ADDENDUM NO. 1
to
PLANS and SPECIFICATIONS
for

Medina River Sewer Outfall, Segment 2
SAWS Job No. 11-2503

Issue Date: November 1, 2010

The purpose of this addendum is to issue revisions and clarifications for the Medina River Sewer Outfall, Segment 2 (SAWS Job No. 11-2503).

**SAN ANTONIO WATER SYSTEM
MEDINA RIVER SEWER OUTFALL PROJECT
SAWS JOB NO. 11-2503**
CONNECTION DETAILS

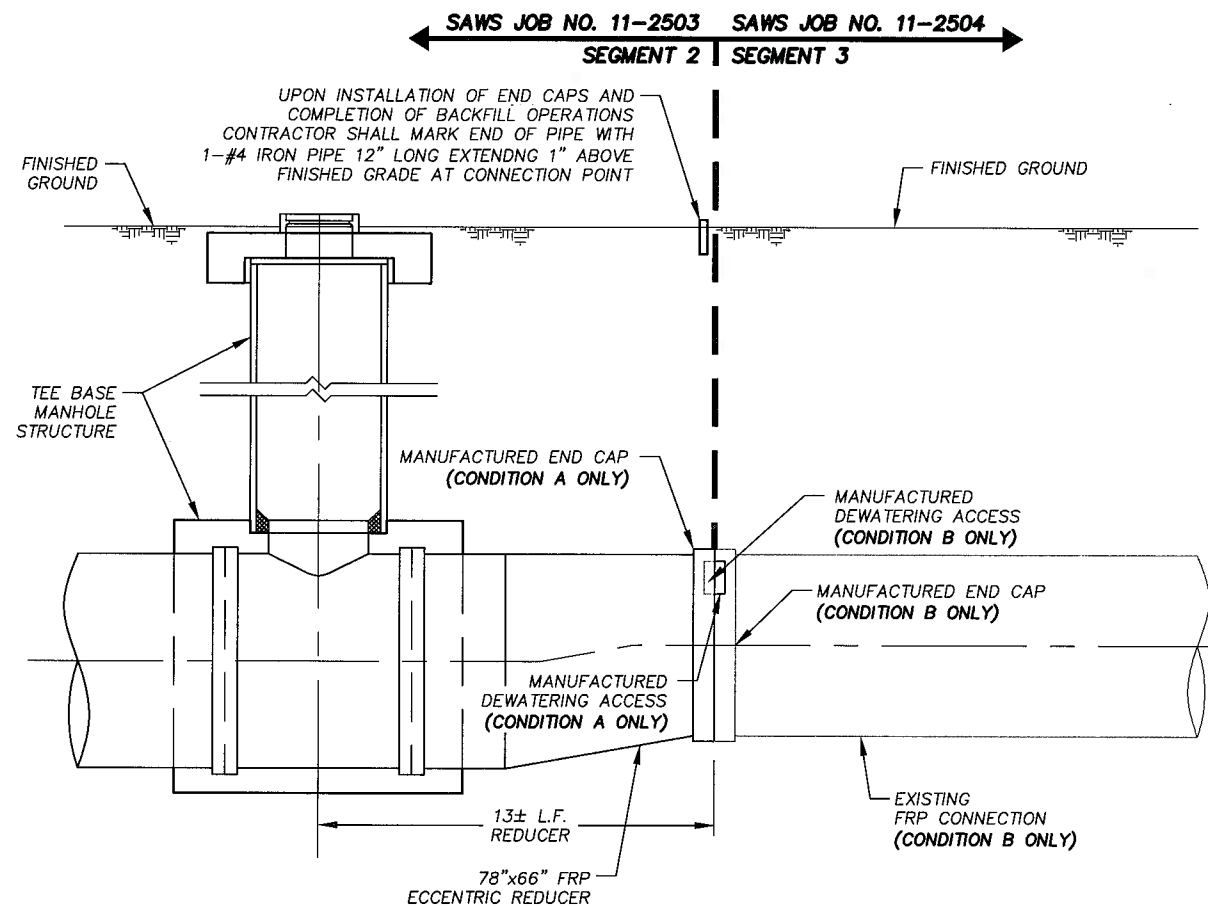
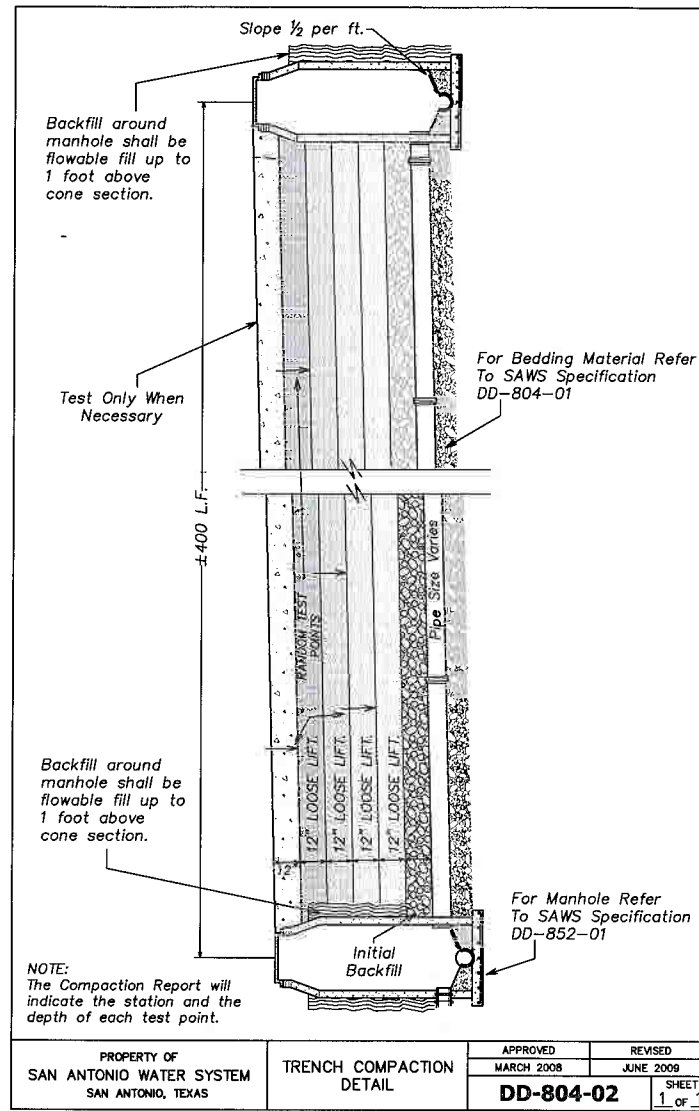
- G. Drawing No. D-02, Sheet No. 42 – Revise the connection detail between Segment 1 and Segment 2. Remove and replace this sheet with the attached plan sheet.

TYPICAL TRENCH DETAILS

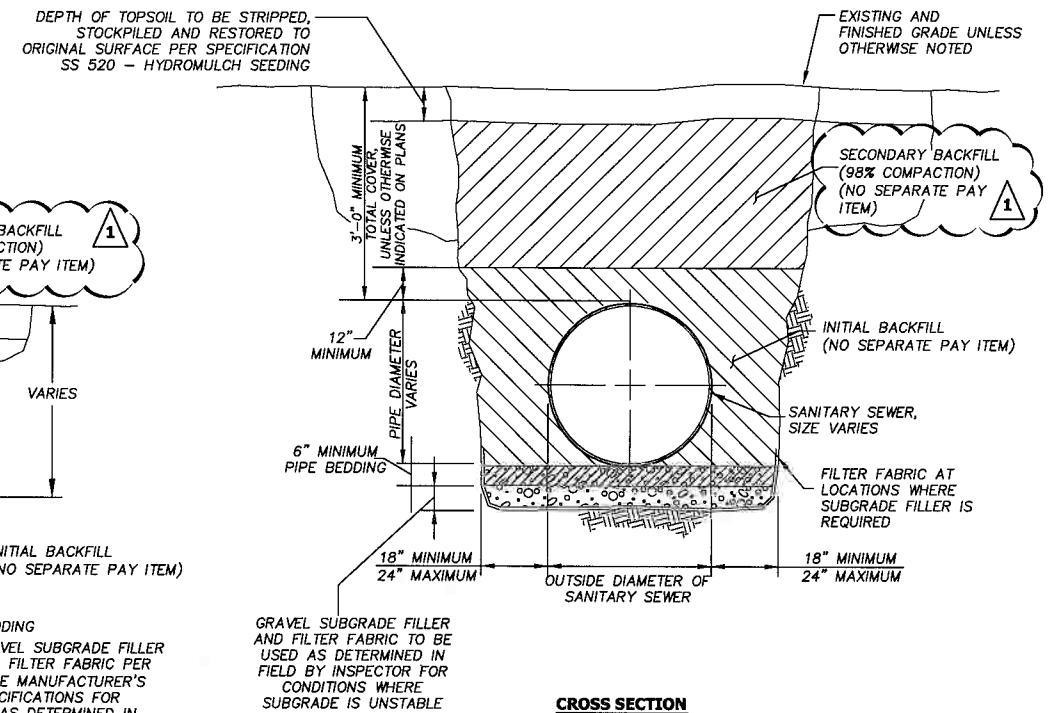
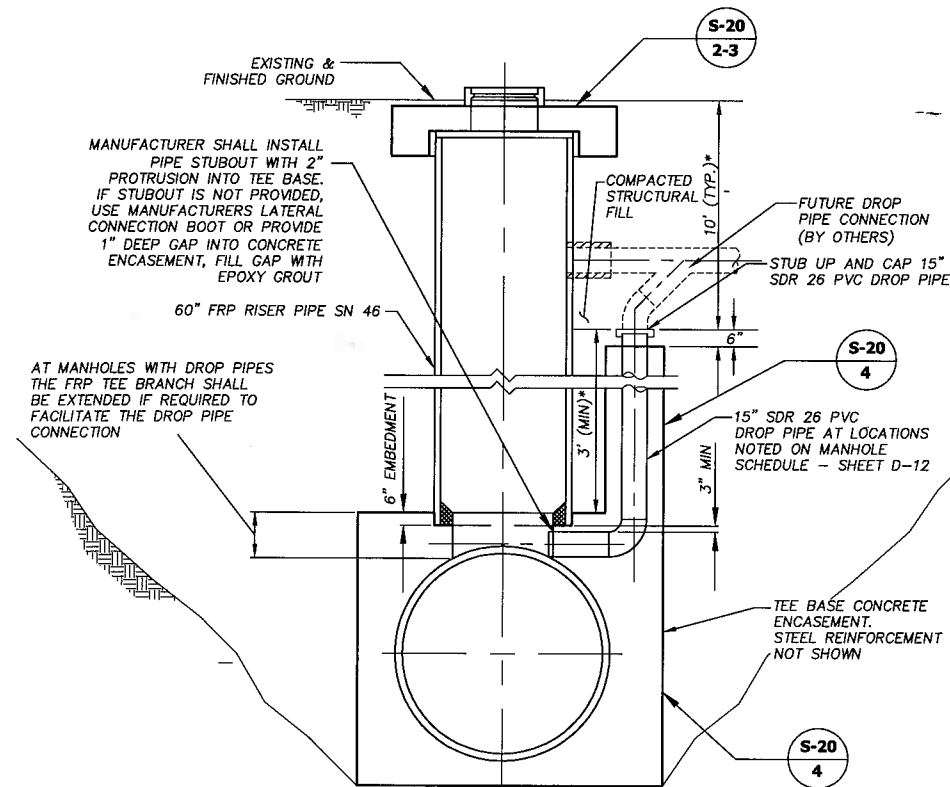
- H. Drawing No. D-08, Sheet No. 44 – Revise the secondary backfill callout on Detail D-08/D and D-08/E to specify 98% compaction. Remove and replace this sheet with the attached plan sheet.

JOB NO.	6866-00
DATE	NOVEMBER 2010
DESIGNER	JQ
DRAWN	BS
CHECKED	BM
DRAWING No.	D-11
SHEET No.	47

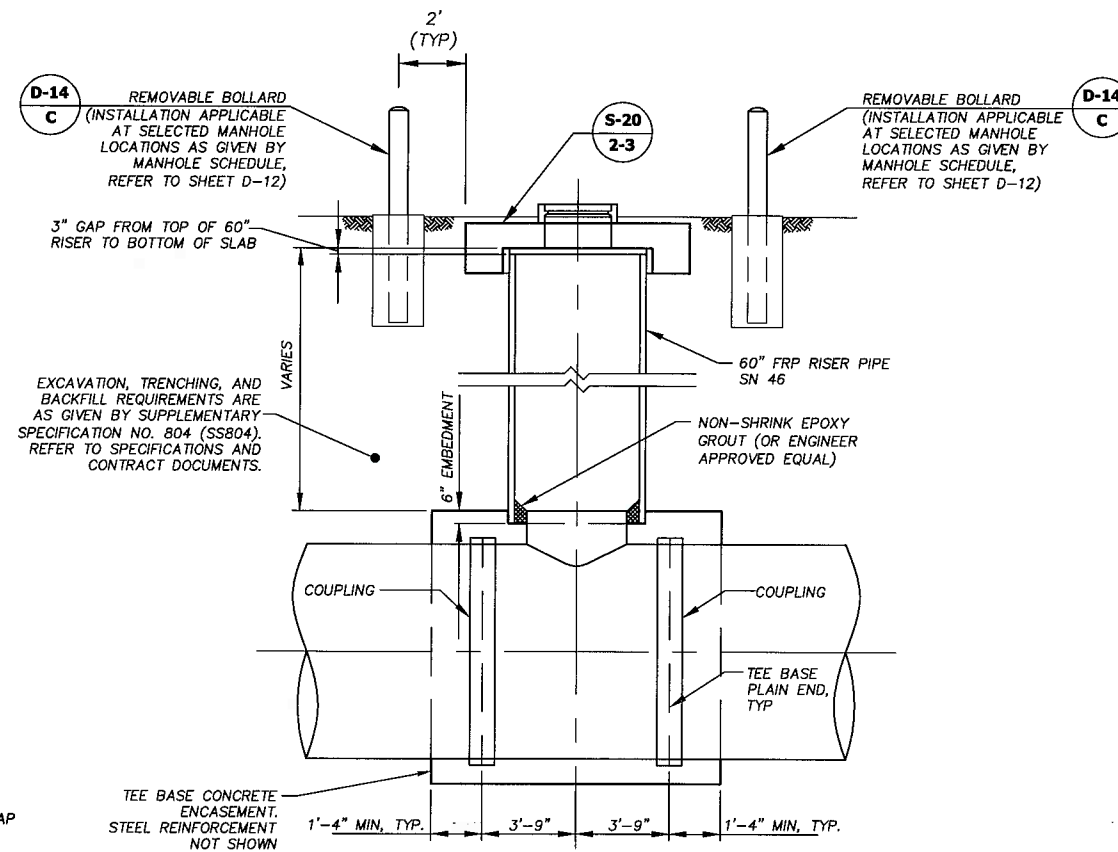
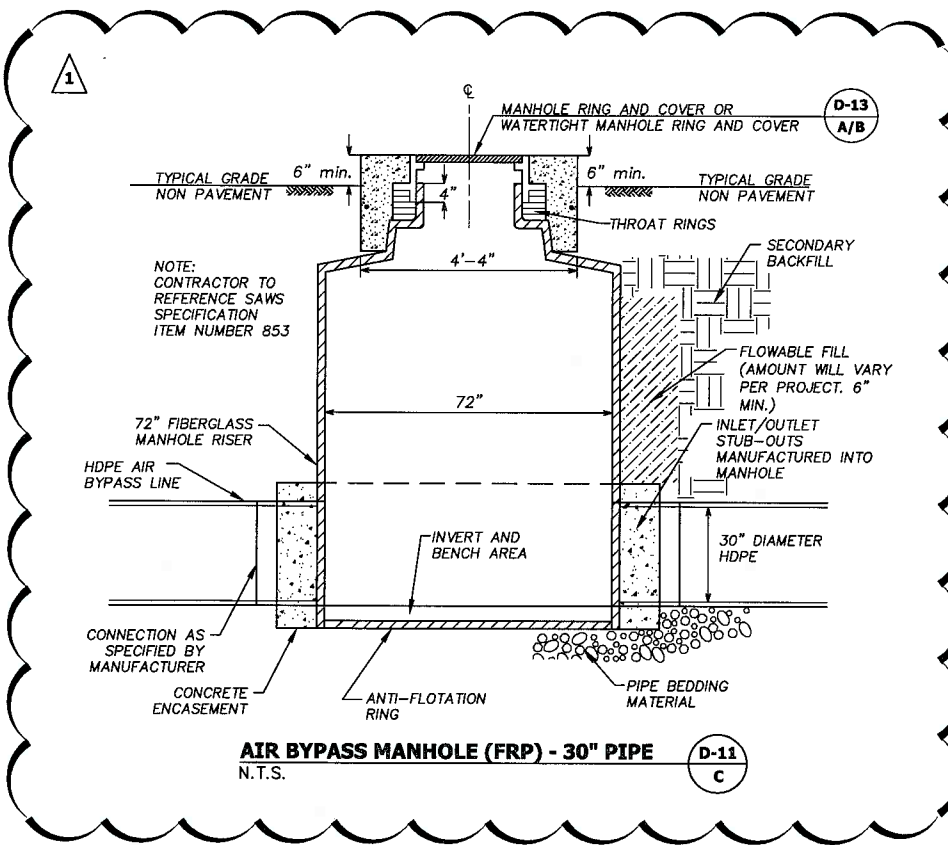
- I. Drawing No. D-11, Sheet No. 47 – Revise graphical representation of concrete encasement. Remove and replace this sheet with the attached plan sheet.

JOB NO.	6866-00
DATE	NOVEMBER 2010
DESIGNER	JD
DRAWN	BS
CHECKED	BM
DRAWING No.	D-12
SHEET No.	48

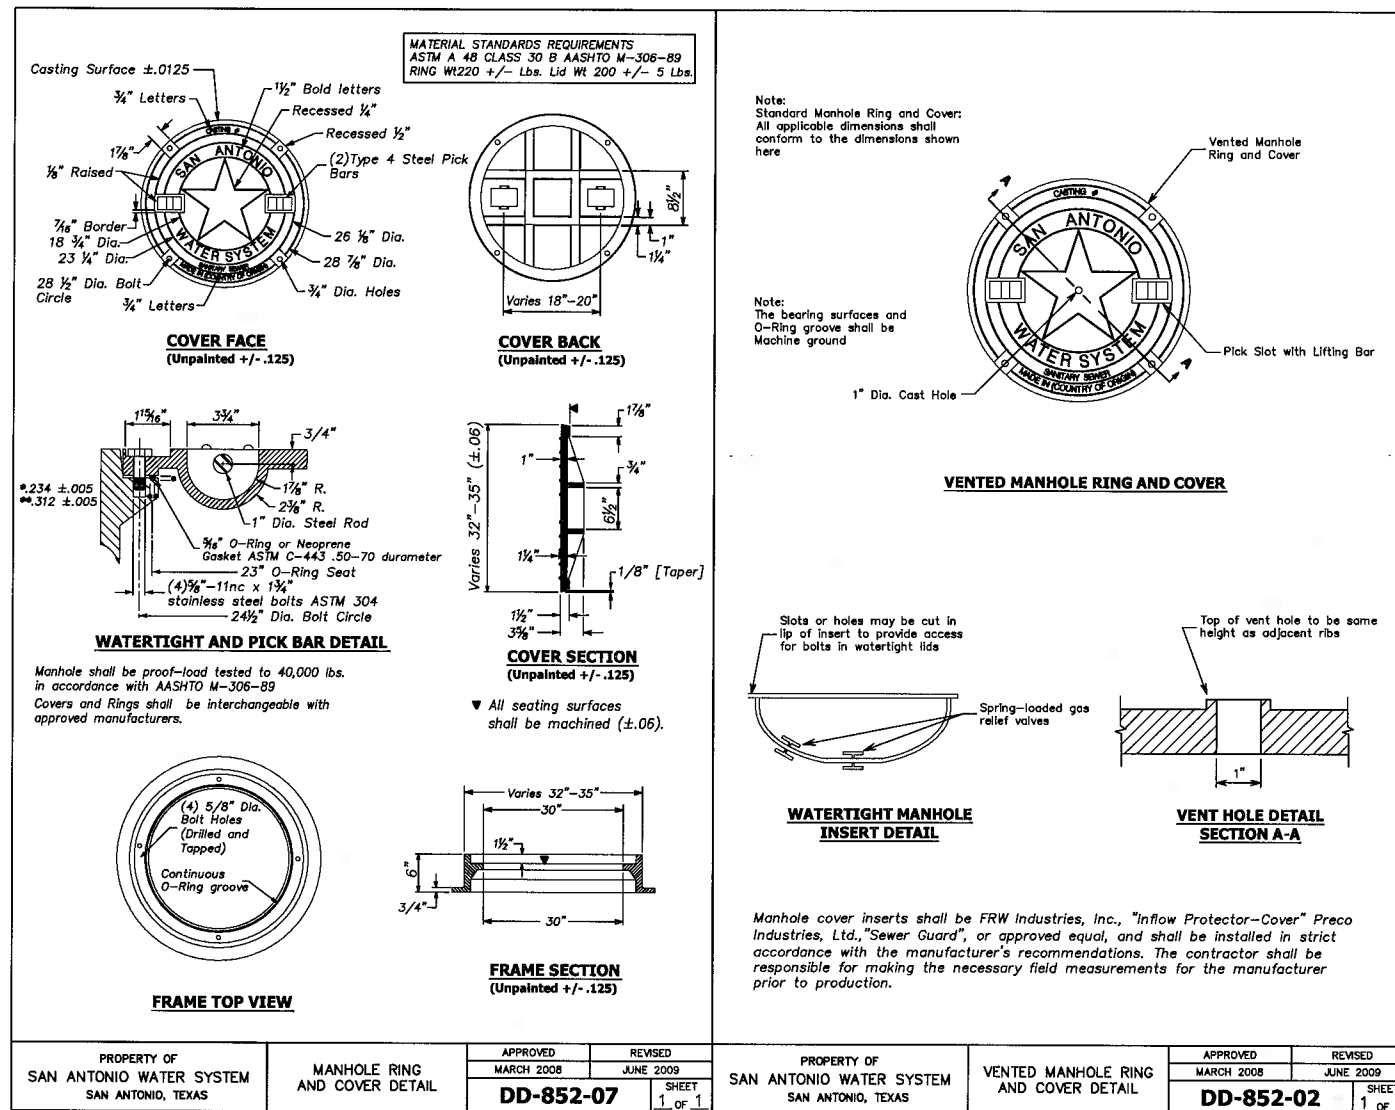
- J. Drawing No. D-12, Sheet No. 48 – Add a note to the manhole schedule that states the following: “All manholes shall be vented by a vented manhole ring and cover unless noted otherwise on the manhole schedule. Remove and replace this sheet with the attached plan sheet.

NOTE: AIR BYPASS PIPING MANHOLES ARE NOT INCLUDED IN MANHOLE SCHEDULE.
 NOTE: ALL MANHOLES SHALL BE VENTED BY A VENTED MANHOLE RING AND COVER UNLESS NOTED OTHERWISE ON THE MANHOLE SCHEDULE.
